NL-13-1734

Joseph M. Farley Nuclear Plant – Units 1 and 2  
Southern Nuclear Operating Company Response to the  
Request for Additional Information Regarding Overall Integrated Plan for  
Reliable Spent Fuel Pool Instrumentation (Order Number EA-12-051)

**Southern Nuclear Operating Company Response to the Request for Additional  
Information Regarding Overall Integrated Plan for Reliable Spent Fuel Pool  
Instrumentation (Order Number EA-12-051)**

SKETCH IN RESPONSE TO RAI ITEM 1b

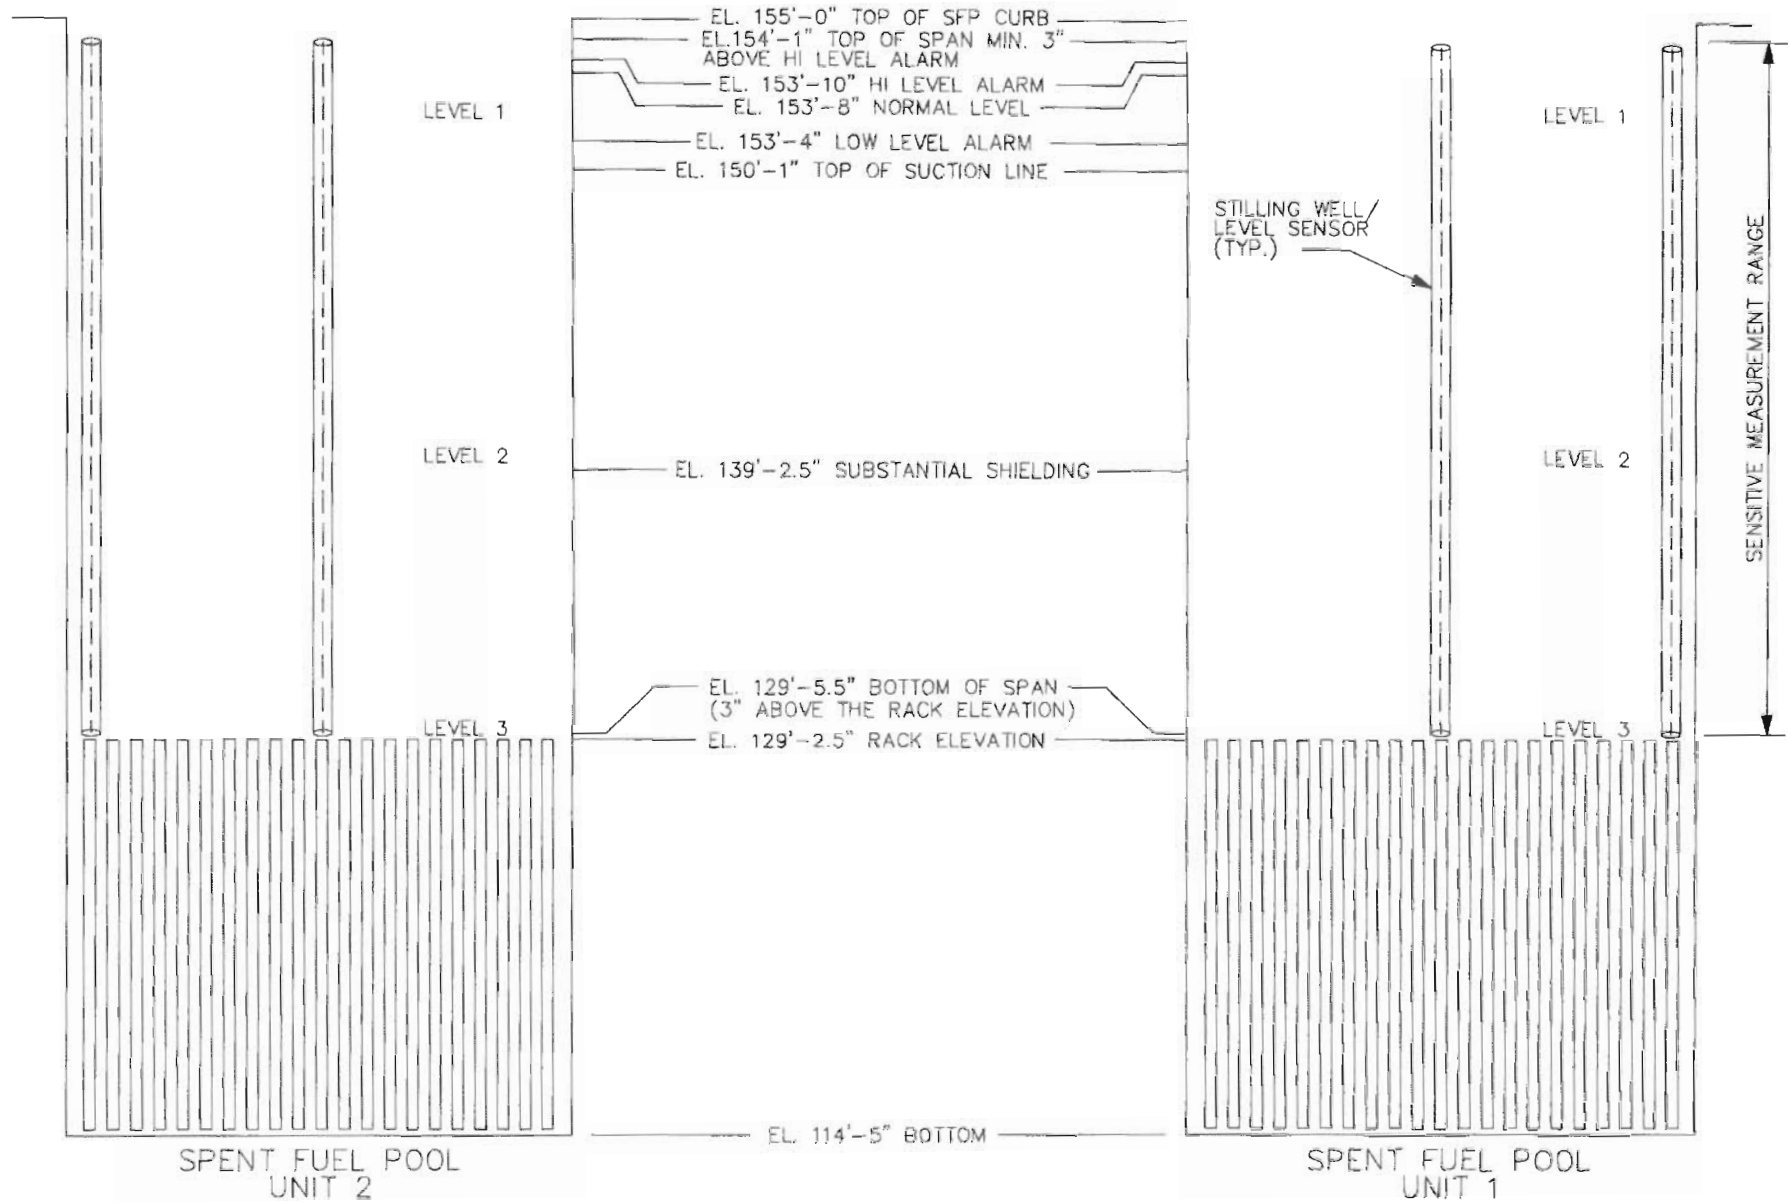
- a) For Level 1, specify how the identified location represents the HIGHER of the two points described in the NEI 12-02 guidance for this level.
- b) A clearly labeled sketch depicting the elevation view of the proposed typical mounting arrangement for the portions of instrument channel consisting of permanent measurement channel equipment (e.g., fixed level probes and/or stilling wells, and mounting brackets). Indicate on this sketch the portion of the level sensor measurement range that is sensitive to measurement of the fuel pool level, with respect to the Level 1, Level 2, and Level 3 datum points.

Enclosure 2 provides a sketch that depicts an elevation view of the Unit 1 and 2 SFP. The sketch depicts the datum values representing Level 1, Level 2, and Level 3. Per NEI 12-02, Level 3 corresponds nominally (i.e., +/- 1 foot) to the highest point of any rack seated in the spent fuel pool. The level sensor sensitive measurement range will span from a minimum of 3 inches above the high SFP level alarm setpoint to 3 inches above the top of the spent fuel pool rack.
